Access Compliance Report

Public Rights-of-Way

(Curb Ramps)

Intersection ID: 54373	Main Street: BENSEVAL_LN	Cross Street: ARNOTT_LN	Location: SE
ADA ID: 3C459457BDEE	Ramp Type: BlendTrans1	Initial Pass/Fail: Fail	Overall Compliance: No
		Severity Score: 10

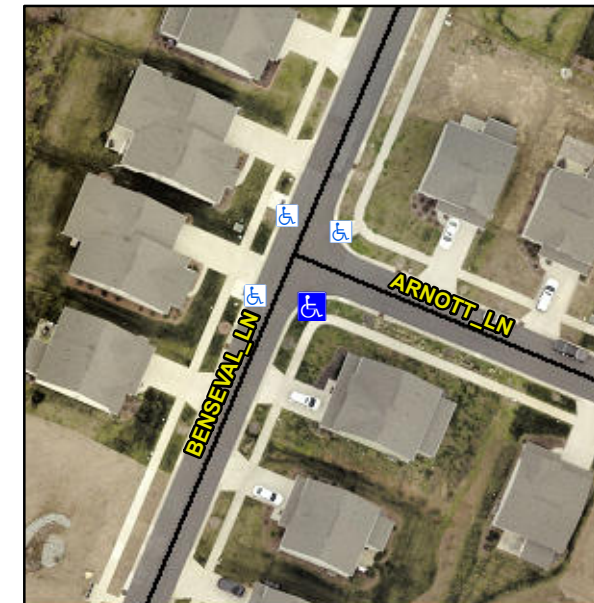
Not Found, R304.5.1, R304.5.3

Compliance	Description	Data	Compliance	Description	Data
N/A	Ramp Length (in)	98.0	Yes	BlendTrans Slope (%)	3.8
No	Ramp Width (in)	47.0	No	BlendTrans XSlope (%)	4.8
N/A	Flare Type LT	N/A	N/A	Flare Type RT	N/A
N/A	Flare Slope LT (%)	N/A	N/A	Flare Slope RT (%)	N/A
N/A	Flare Traversable LT?	N/A	N/A	Flare Traversable RT?	N/A
N/A	Landing Length (in)	N/A	N/A	DWS Provided?	N/A
N/A	Landing Width (in)	N/A	N/A	DWS Contrast?	N/A
N/A	Landing Slope (%)	N/A	N/A	DWS Length (in)	N/A
N/A	Landing X Slope (%)	N/A	N/A	DWS Full Width?	N/A
N/A	Landing Curb? (Y/N)	N/A	N/A	DWS Offset (in)	N/A
N/A	Shared Landing?	N/A			
N/A	Gutter Ponding?	N/A	N/A	Gutter Slope (%)	N/A
N/A	Gutter Lip Ht (in)	N/A	N/A	Gutter X Slope (%)	N/A
N/A	Painted X Walk1?	No	N/A	Painted X Walk2?	No
	X Walk 1 Direction	To N		X Walk 2 Direction	To W
	X Walk 1 Width (in)	N/A		X Walk 2 Width (in)	N/A
	X Walk 1 Slope (%)	5.9		X Walk 2 Slope (%)	5.4
	X Walk 1 X Slope (%)	1.2		X Walk 2 X Slope (%)	5.9

N/A	Ramp inside XWalk1?	N/A	N/A	Ramp inside XWalk2?	N/A
	Road Slope (%)	4.2		Clear Space?	N/A
	Road X Slope (%)	6.8	N/A	Clear Space to XWalk (in)	N/A
N/A	Any Obstructions?	N/A	N/A	Storm Grate/Utility Hazard?	N/A
	Obstruction Type			Storm Grate/Utility Type	
		N/A			N/A
			Yes	Surface Condition? (G/P)	Good
			No	Curb Slope (%)	8.0

Remove & Replace Curb Ramp With Two New Directional Ramps or Equivalent.
